The Calcutta Gazette

WEDNESDAY, MAY 31, 1922.

NOTICES TO MARINERS.

The following Notices are republished for general information.

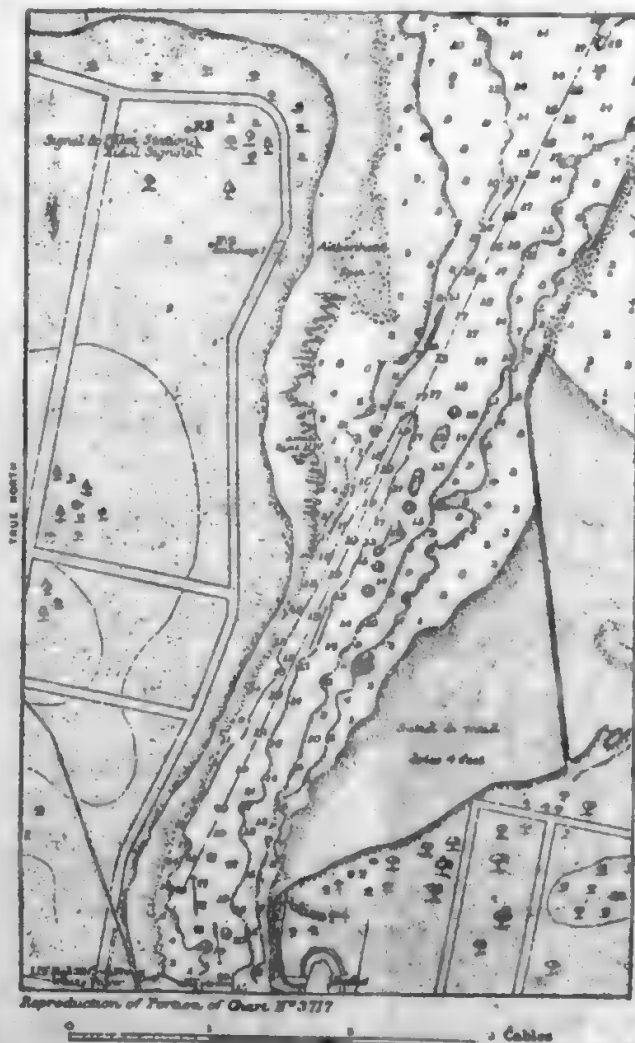
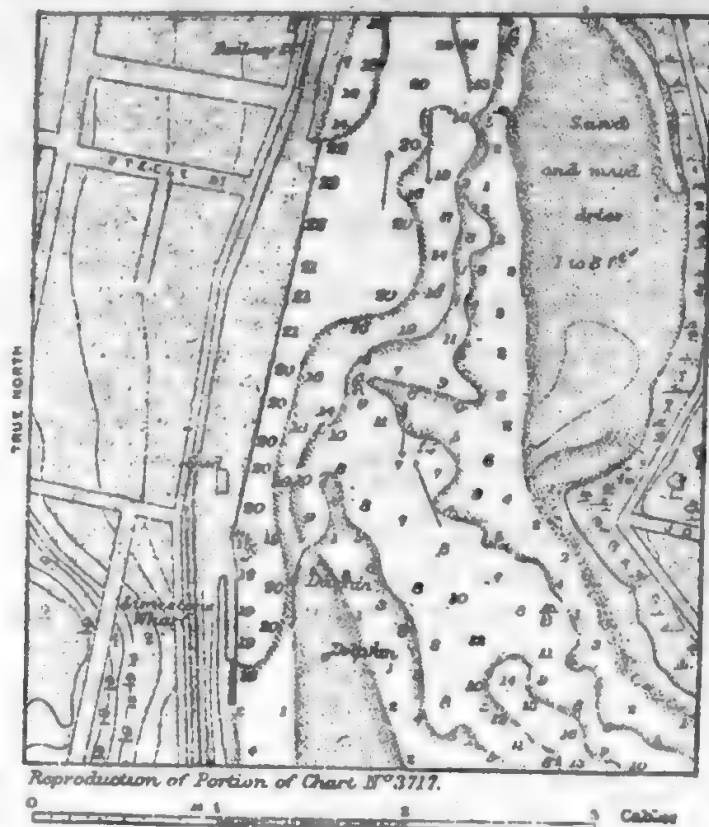
Details.—The accompanying reproductions of portions of the plan of the River Mersey on chart No. 3717 show the necessary corrections to that plan with regard to depths, the positions of dolphins, &c., and new wharfs which have been constructed at West Devonport.

Reproduction of Portions of Chart No. 1701.

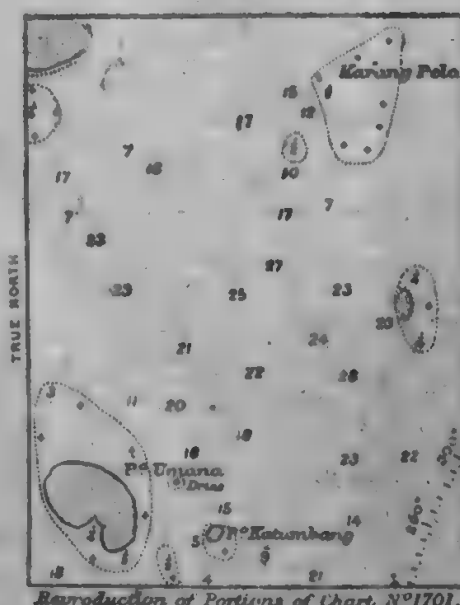
Details.—The accompanying reproduction of a portion of the plan of Tarusan bay on chart No. 1701 shows the necessary corrections to that plan with regard to rocks and shoals in the vicinity of Pulo Setan Kechil.

Details.—The accompanying reproduction of portions of the plan of Tabekat bay on chart No. 1701 shows the necessary corrections to that plan with regard to reefs and shoals in the approaches to Tabekat bay.

Reproduction of Portion of Chart N°1459

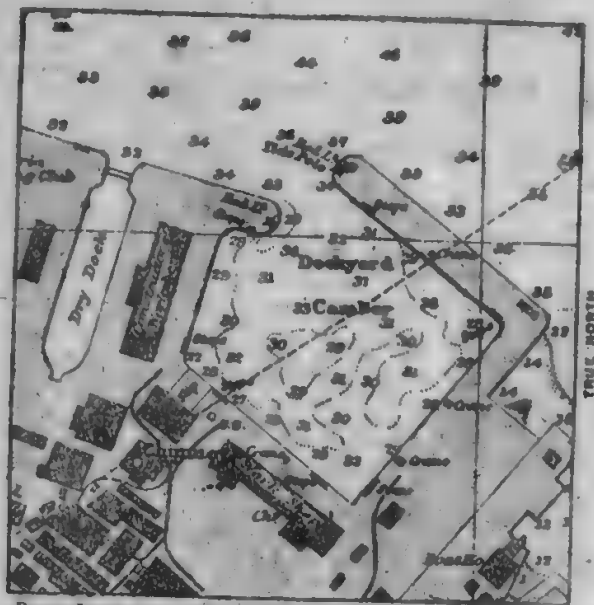
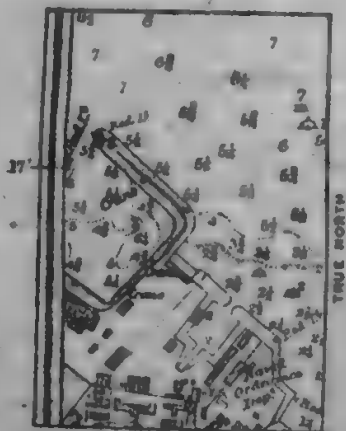
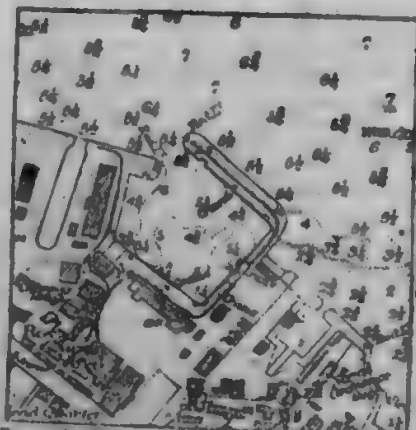
Details.—Amendment to the charts with regard to depths in the Dockyard camber, embodying the latest information received, is shown on the accompanying reproduction of portions of charts Nos. 1459, 3280, 3279.

It will be seen that the depths have slightly decreased.

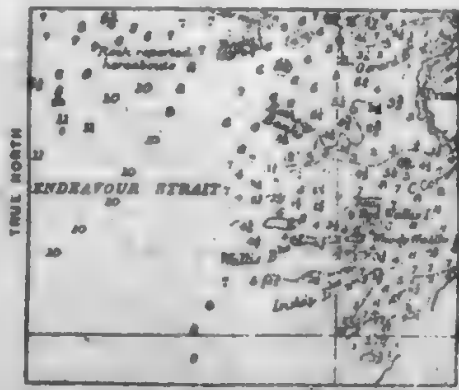
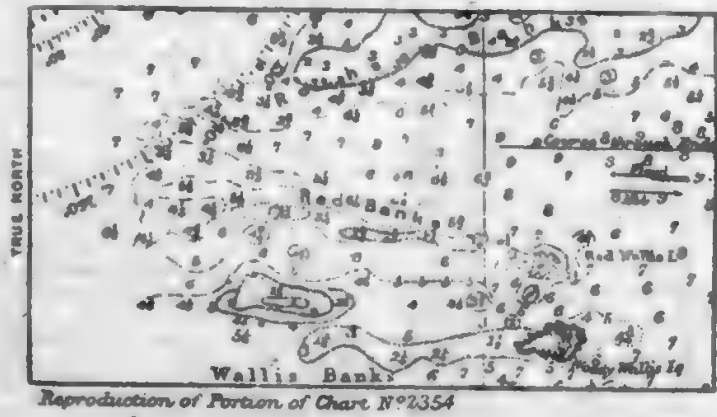
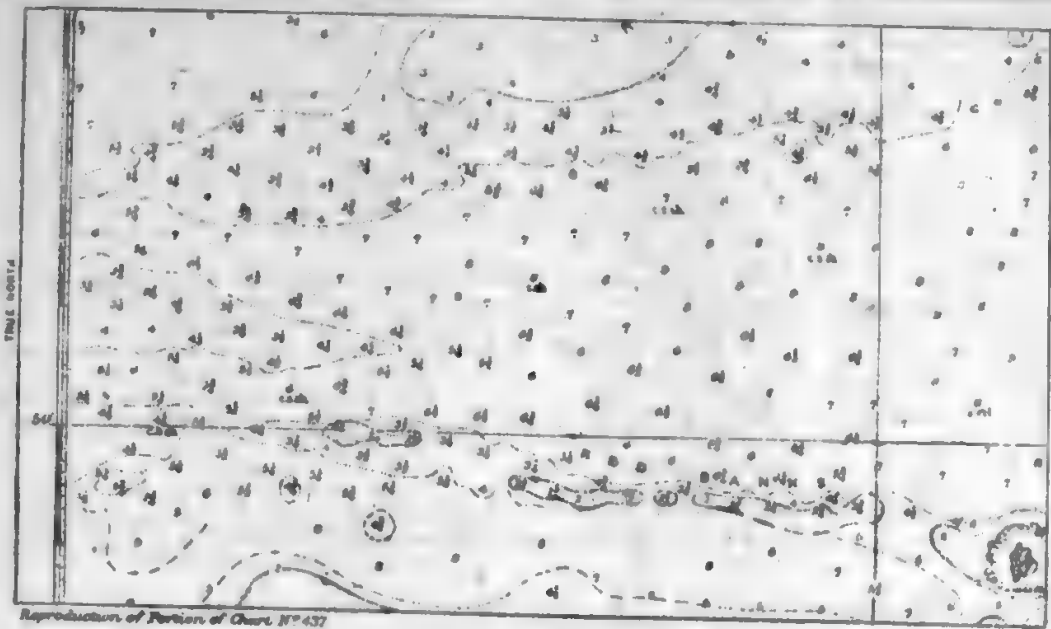
Details.—The accompanying reproductions of portions of charts Nos. 437, 2375, 2354, 447 show the amended depths south-westward and southward of Rothsay banks in the western approach to Endeavour strait, as a result of a recent survey.

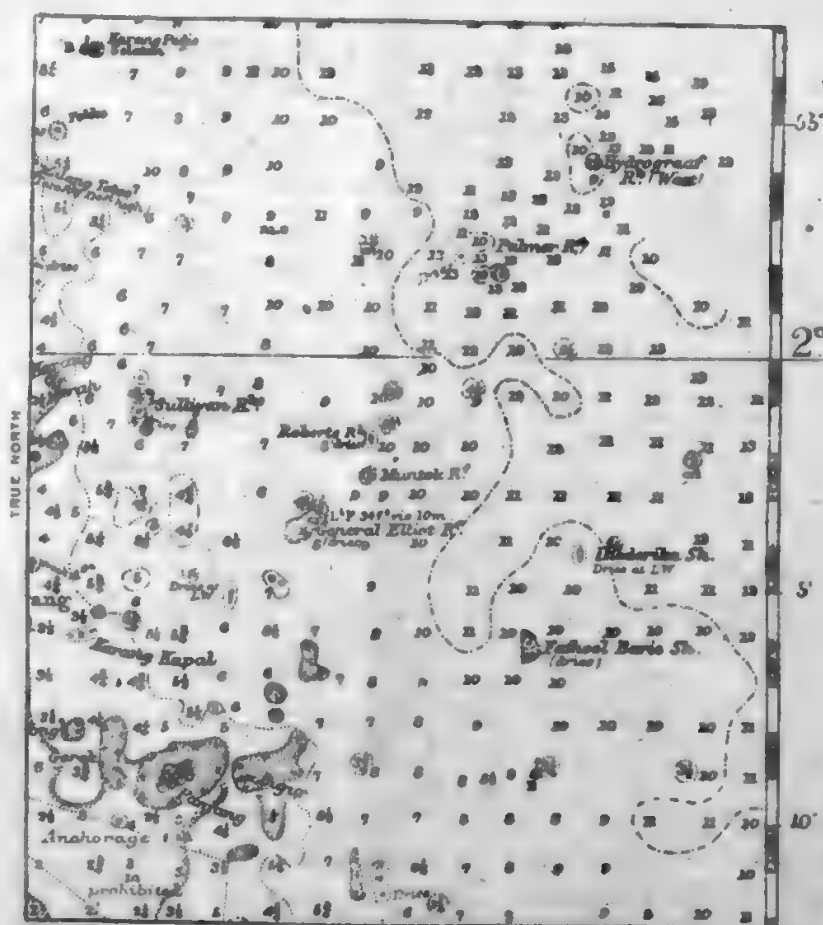
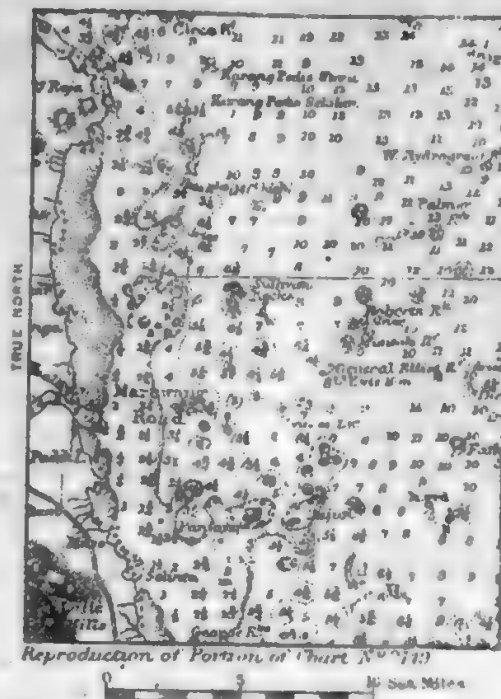
Details.—The accompanying reproductions of portions of charts Nos. 2597, 2149 show the necessary amendments with regard to shoals and depths in the approaches to Marawang road.

Reproduction of Portions of Chart N° 2761

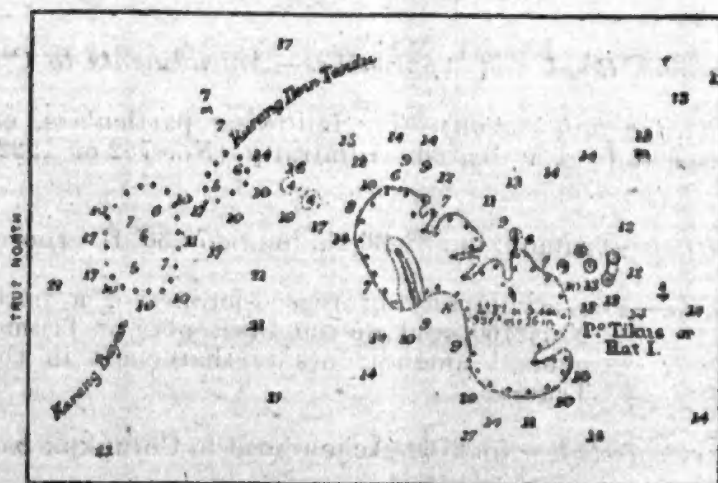
Details.—The accompanying reproduction of a portion of the plan of Sikakap strait on chart No. 2761 shows the necessary corrections to that plan with regard to shoals in the channel northward of Pulo Ti Nussa.

Details.—The accompanying reproduction of a portion of the plan of Benkulen road on chart No. 2761 shows the necessary corrections to that plan with regard to shoals north-westward of Pulo Tikus.

Reproduction of Portion of Chart N° 2760.

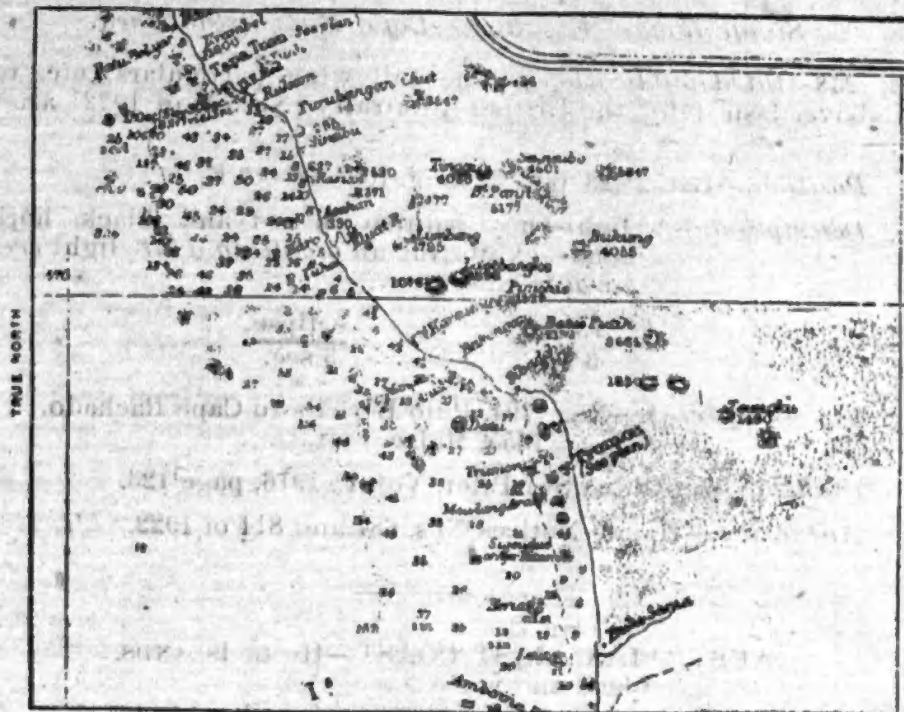
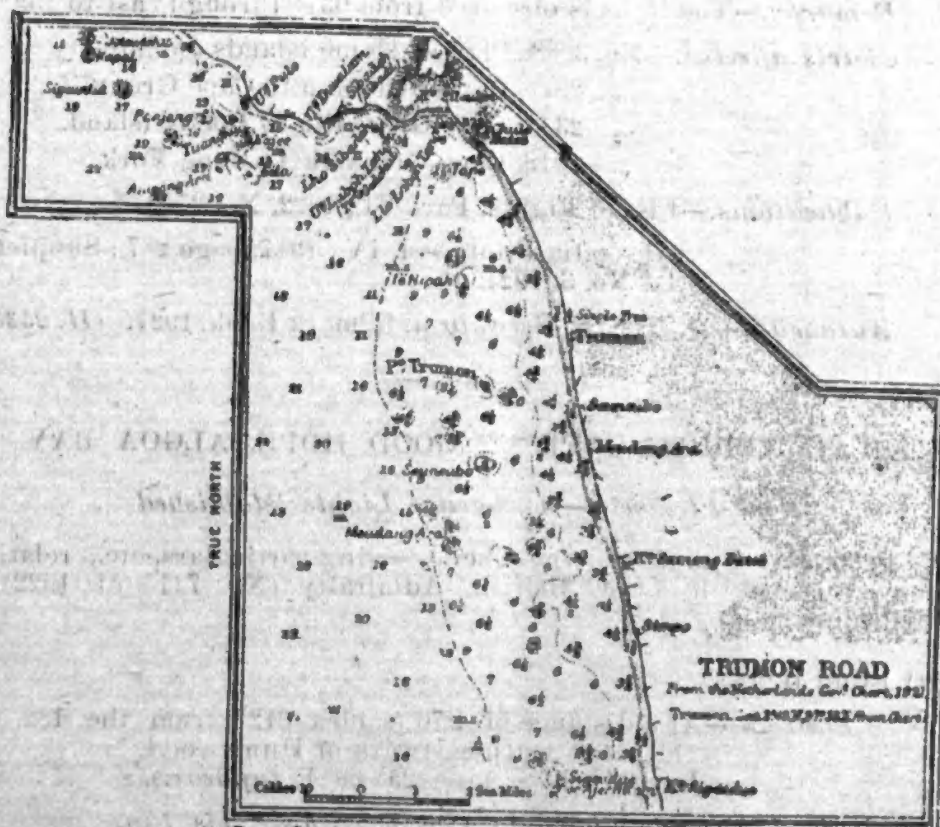
Details.—The accompanying reproductions of a portion of chart No. 2760, and of the inset plan of Trumon road, show general amendments to that chart in the vicinity of Trumon.
